**ADMINISTRATIVE OFFICE OF THE COURTS
PROCUREMENT AND CONTRACT ADMINISTRATION
2003 C COMMERCE PARK DRIVE
ANNAPOLIS, MARYLAND 21401**

**Questions/Responses No. 1
RFP Project No. K12-0074-25
Design and Build of AOC Office Space
May 31, 2012**

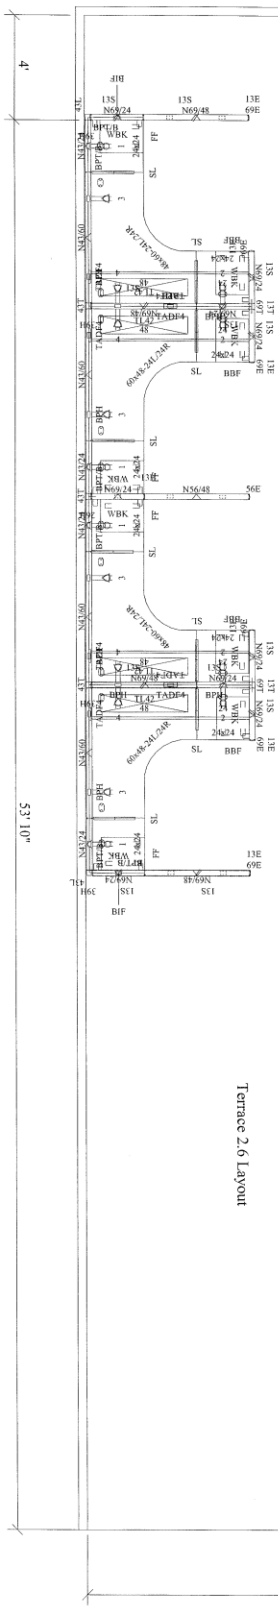
25. Does the project require the "Contractor" to provide the following items:

- a. Masonry – patch / point-up existing cracks?
- b. Automatic Entry Doors?
- c. Fire Extinguishers?
- d. Residential Kitchen Appliances?
- e. Window Treatments?
- f. Access Control / Card Readers?

Response: a. Yes, b. No, c. Yes, d. Yes, e. No, f. No.

Terrace 2.6 Layout

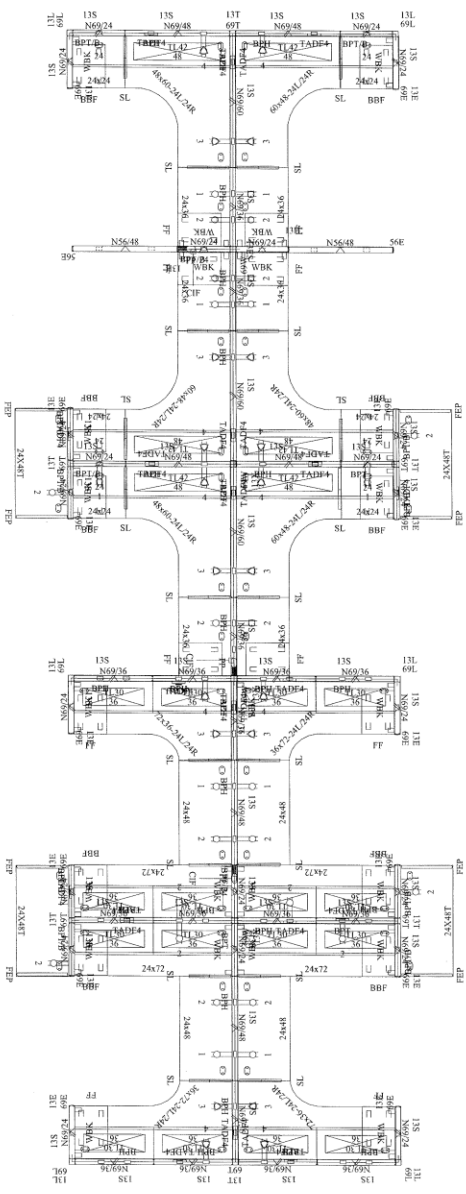
7. 17 Workstations to be relocated into rear warehouse space is done by others, but in this bid we are to include all elect, data and communication requirements for these stations? Can you supply layout of these stations?

26. Provide cut sheets of workstations and accessories (including power poles) provided by Owner. Confirm ceiling height proposed (to be maintained) is conducive to proposed workstation layout.

Response: Include all electrical/telephone/data for workstations. Drawings are attached.

Response: Yes.
